REPORT OF: URBAN DESIGN COMMISSION	PRESENTED: October 19, 2011
TITLE: 722 Williamson Street – PUD(GDP) for a 34-Unit Mixed-Use Building. 6 th Ald. Dist. (23566)	REFERRED: REREFERRED: REPORTED BACK:
AUTHOR: Alan J. Martin, Secretary	ADOPTED: POF:
DATED: October 19, 2011	ID NUMBER:

TITLE: Aprox. 306 Livingston – Third Lake Ridge Historic District – Construction of new 5-story mixed-use development including 39 apartment units (currently on parcel of 722 Williamson) – 6th Ald. District. Contact: Randy Bruce and Marty Rifken (23433)

Regarding: **Approx. 306 Livingston Street – Third Lake Ridge Historic District – Construction of new 5 story mixed use development including 39 apartment units (currently on parcel of 722 Williamson). 6th Ald. District. (Legistar #23433)**

**306 South Livingston Street
Visually Related Study Area
Landmarks Commission - 8/2011**

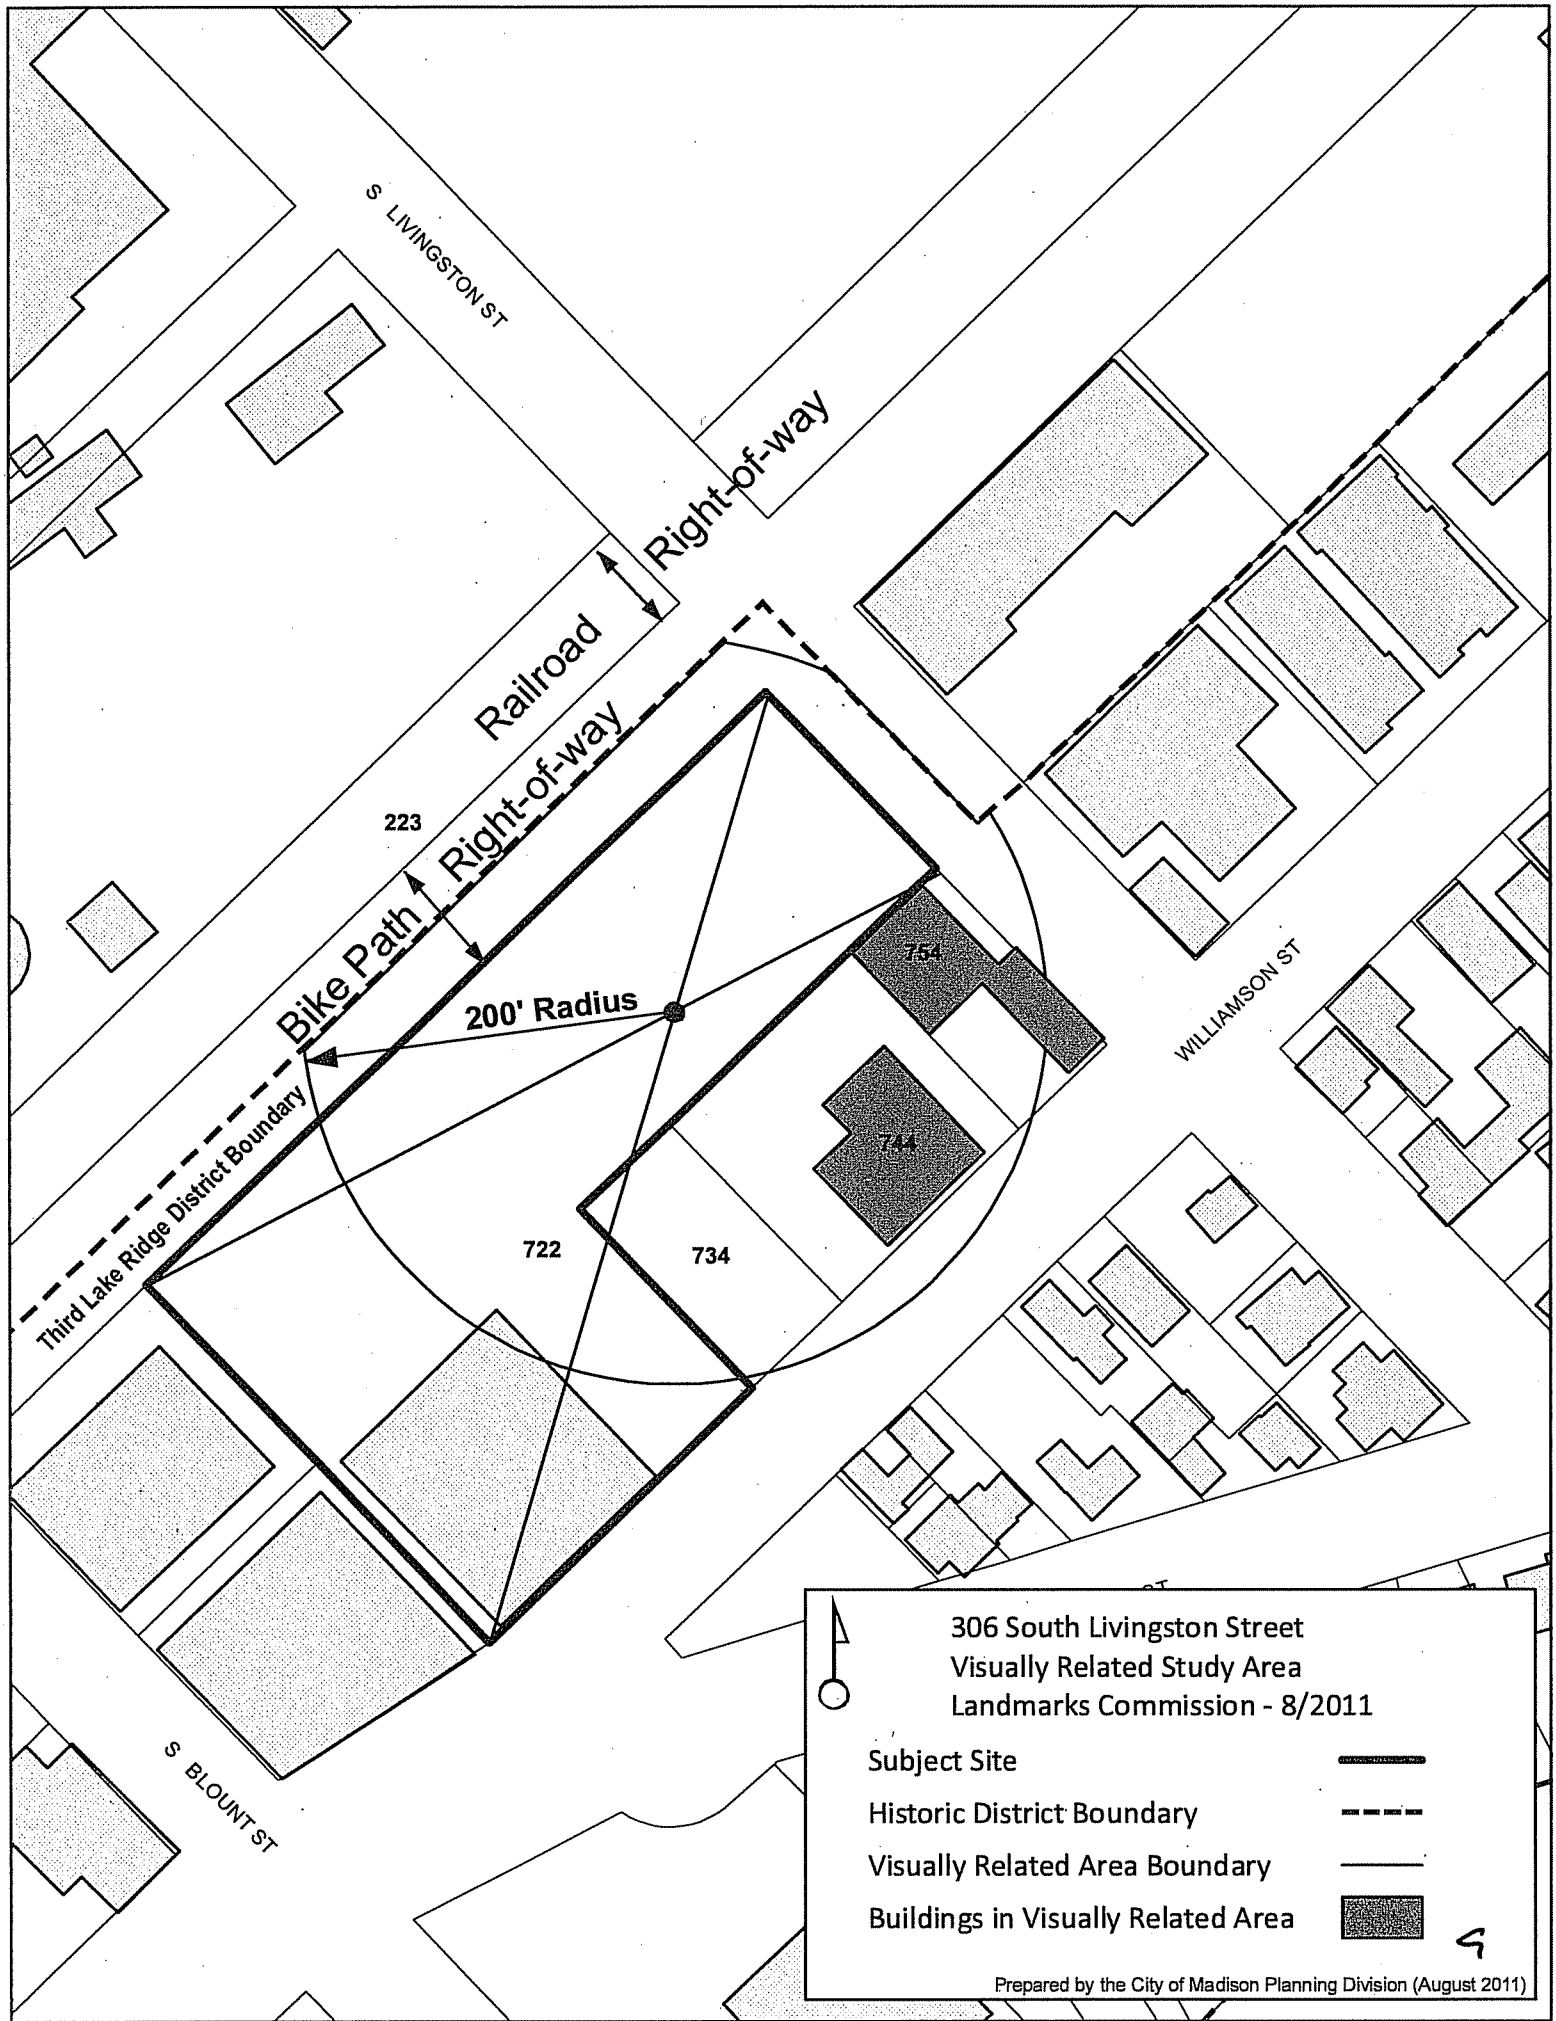
1. The brick color should be changed to a darker color which would be more compatible with the materials in the visually related area and in the overall context of that portion of the district. A review of structures within the visually related area and the surrounding context indicates a predominant use of darker, mostly red, brick as the primary building material.

2. The building should have a "top" with the expression of a more substantial cornice at the termination of the masonry at the 4th floor in an effort to be compatible with the perceived heights of buildings in the visually related area and in the overall context of that portion of the district.

3. The change in wall materials (from brick to metal) at the stair towers results in a vertical break in the masonry wall surface which indirectly interrupts the rhythm of solids and voids in the elevation. Staff suggests the continuation of the masonry material at the stair towers to unify the elevation and make it more compatible with other buildings in the visually related area and in the overall context of that portion of the district.
